Project reference: Former Newton Pit
BRRTS No. 02-36-000268

<u>Number of originals:</u>	<u>Number of copies:</u>	<u>Description:</u>
One	Zero	Revised Remedial Action Options Report and Conceptual Design with NR 718 Soil Management Plan

Project Memorandum

Revised Remedial Action Options Report & Conceptual Design Report Former Town of Newton Gravel Pit, 3130 Hecker Road, Manitowoc, Wisconsin

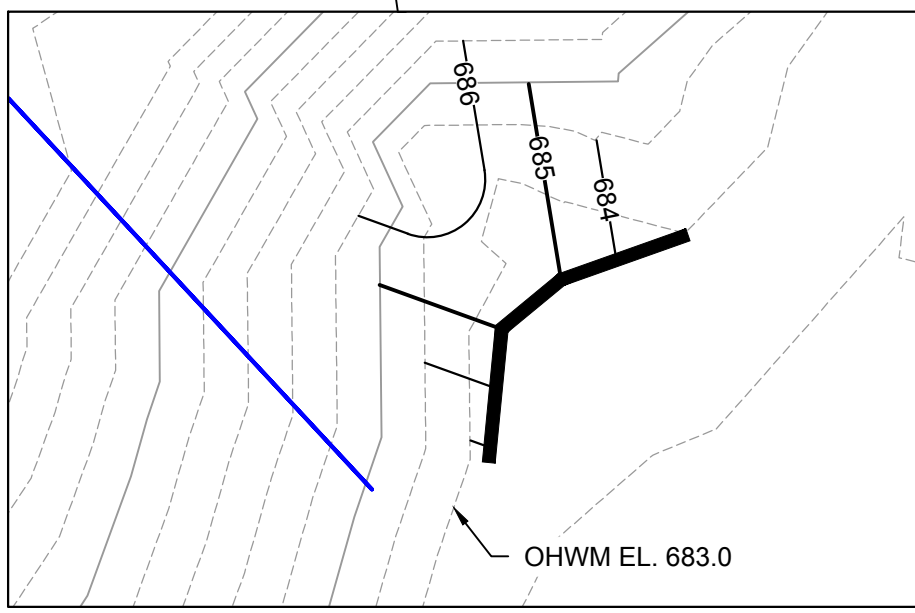
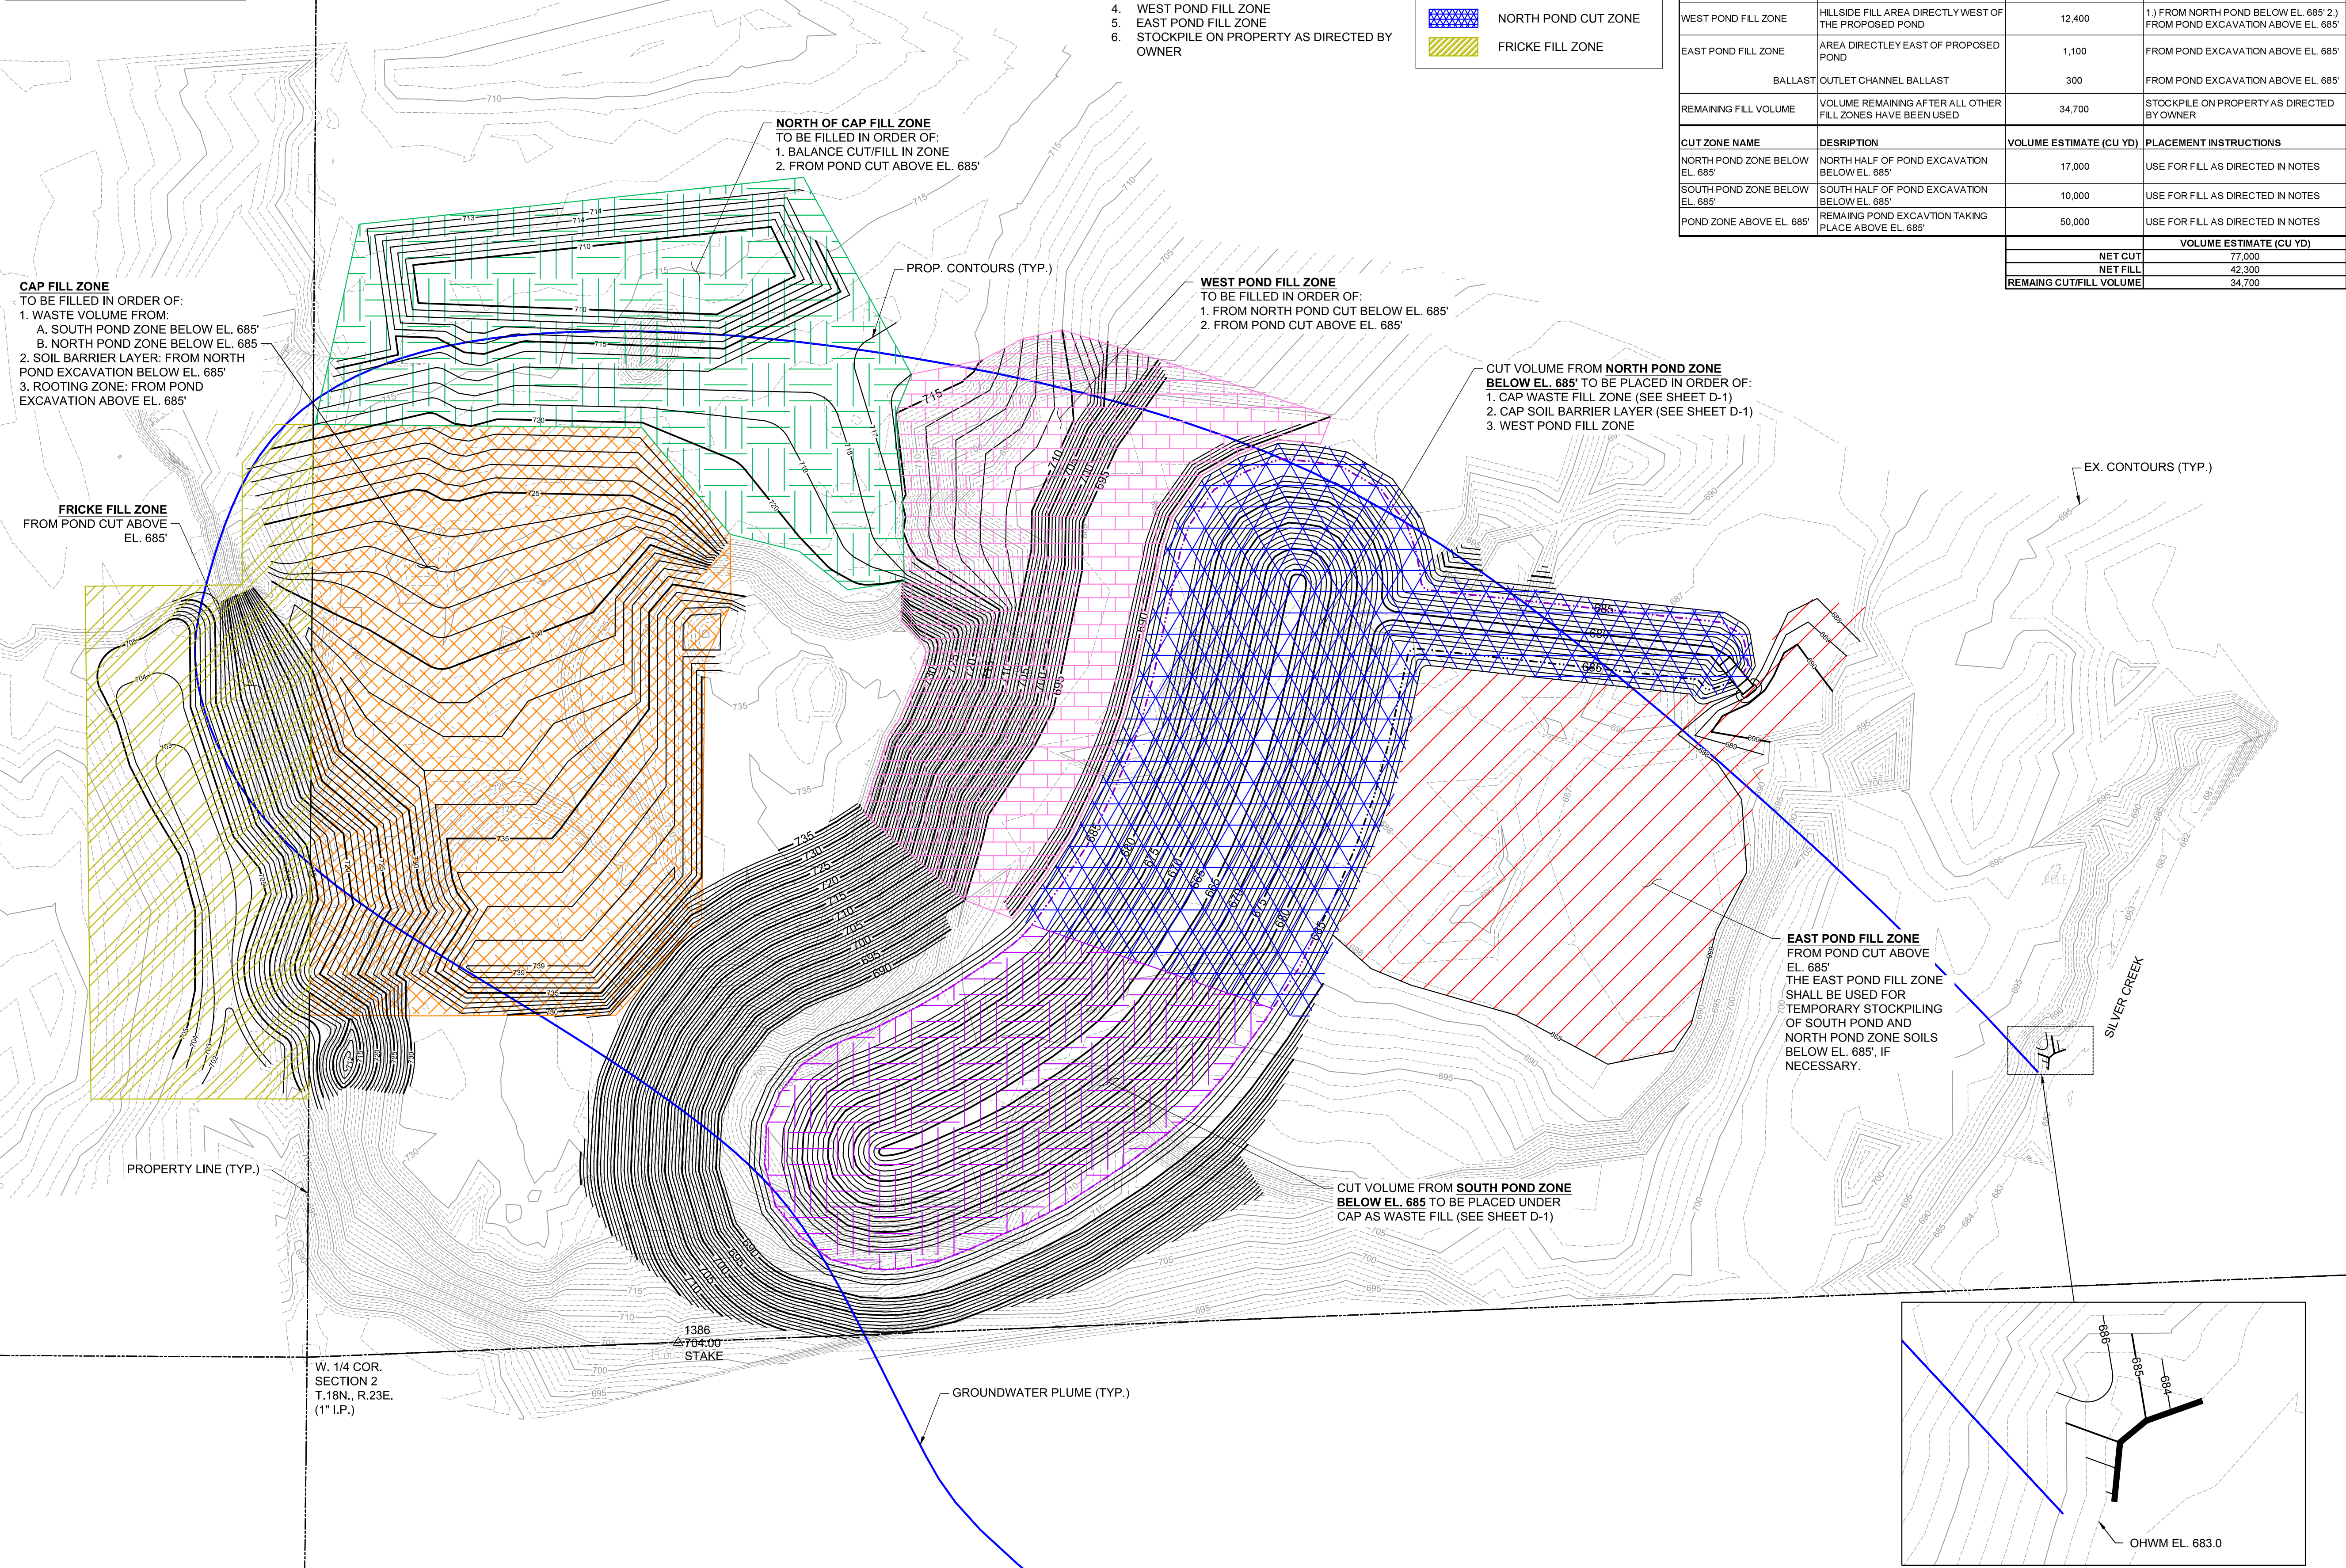
- Page 26, 5.2.1 Engineered Treatment Pond; Page 35, 5.4, Request for Approval: Need a more specific soil management and soil characterization section with text and a figure to explain how contaminated soil will be addressed and locations of placement. Also, if any NR 718 exemptions are needed or not.

- Soil Management: It should be specifically presented in the report and figure where the soil will be relocated and how it is addressed, either under the cover, by phytoremediation, bio-pile, etc. Contaminated soil above the direct contact and/or groundwater pathway standards will need to be addressed with some type of remediation, like stated above.

Response: Additional characterization activities and a waste determination for the soils to be excavated have been completed. A report documenting these activities has been submitted to the WDNR in a NR 718 Soil Sampling Results and Waste Determination Technical Memorandum². Additionally, the Conceptual Design portion of the report has been updated with Section 5.3, NR 718 Management of Contaminated Soil. The section summarizes the soil characterization information, discusses the NR 718 exceptions, and presents a Soil Management Plan.

Response: The Conceptual Design portion of the RAOR report has been updated with Section 5.3, NR 718 Management of Contaminated Soil. The section summarizes the soil characterization information, discusses the NR 718 exceptions, and presents a Soil Management Plan.

The Grading Plan–Cut/Fill Plan, Figure G-4, from the project plans and specification bidding document is attached. It provides a succinct engineering description of the Soil Management Plan and a visual presentation for each of the cut and fill zones. Presented below is a written summary of the Plan.
